American Hakko Products, Inc.

# PRODUCT BULLETIN

**Bulletin No:** PB419  
**Issue Date:** 6-14-2018  
**Effective Date:** 6-14-2018

**Description/Title:**  
New Spacer for Feeder Tube Unit and FX-1001

**Part No:**  
B5183

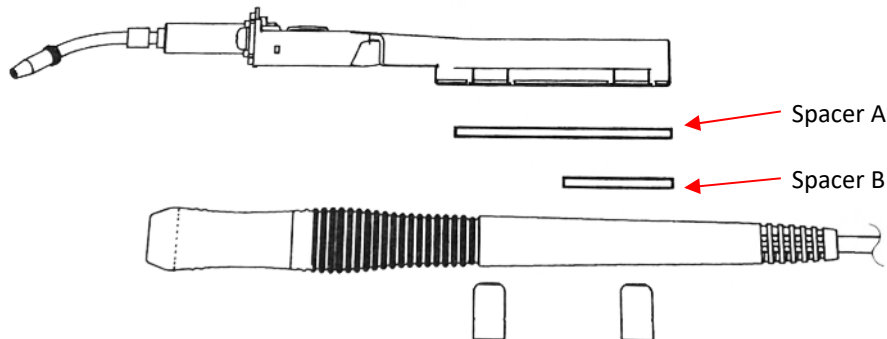
When using the HAKKO 373 or HAKKO 374 Solder Feeder units, these spacers are required when attaching the tube unit (PNs: B3477 or B3478) to the FX-1001 Handpiece. The spacers are a foam rubber with adhesive on one side. The larger spacer (Spacer A) should be attached to the bottom of the tube unit using the adhesive side. The smaller spacer (Spacer B) should be attached to Spacer A, again using the adhesive side. After the spacers have been attached, the tube unit can be attached to the handpiece using the metal clips that were included with the tube unit. See the diagram below.

Material	Foam Rubber
Color	Black
Size	Spacer A – 50 x 10 mm Spacer B – 25 x 10 mm
Attachment	Adhesive – Single Side
